# Pipe Protector and Clip Installation

**Bulletin type:** Service Campaign  
**Reference number:** N/A  
**Campaign reference:** SCB 00 F 001  
**Attention:** Retailer Aftersales Managers, Retailer Service Managers, Retailer Service Advisors, Retailer Technicians, Retailer Parts Managers  
**Affected vehicles:** McLaren 720S, McLaren 765LT, McLaren GT  
**Situation:** Installation of pipe protectors and clip to the WCAC Inlet  
**Procedure:** Action affected vehicles during PDI and those immediately available at the Retailer premises (including stock, demo and showroom vehicles). Please refer to the information outlined in this document to complete the required work  
**Date:** 6<sup>th</sup> August 2025

Image 1: Overview of the installation location

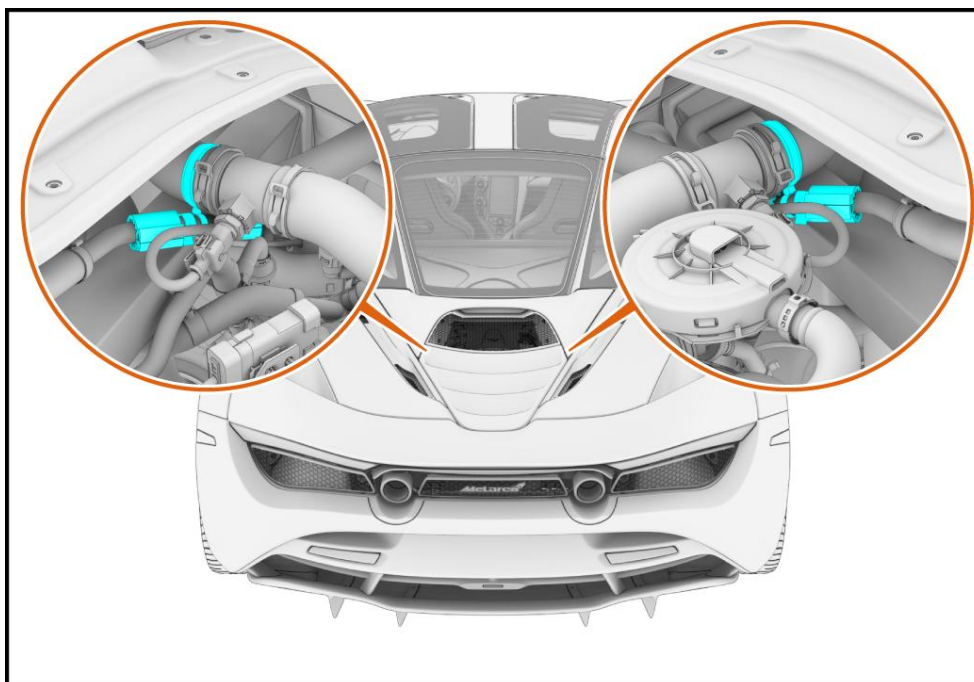
Through continuous product quality monitoring, McLaren Automotive has identified that on some McLaren 720S, McLaren 765LT and McLaren GT vehicles, the clearance between the WCAC inlet pipe and the top hose varies between vehicles. To ensure these vehicles are up to standard, McLaren Automotive is instructing Retailers to install pipe protectors and a C-clip onto the WCAC inlet pipe.

To carry out the required work to install the pipe protectors and clip for this Service Campaign, follow McLaren Service Portal (MSP) D055268 “Rework – High Temperature Radiator (HTR) Top Hose to Water Charge Air Cooler (WCAC) Inlet Pipe” work instruction.
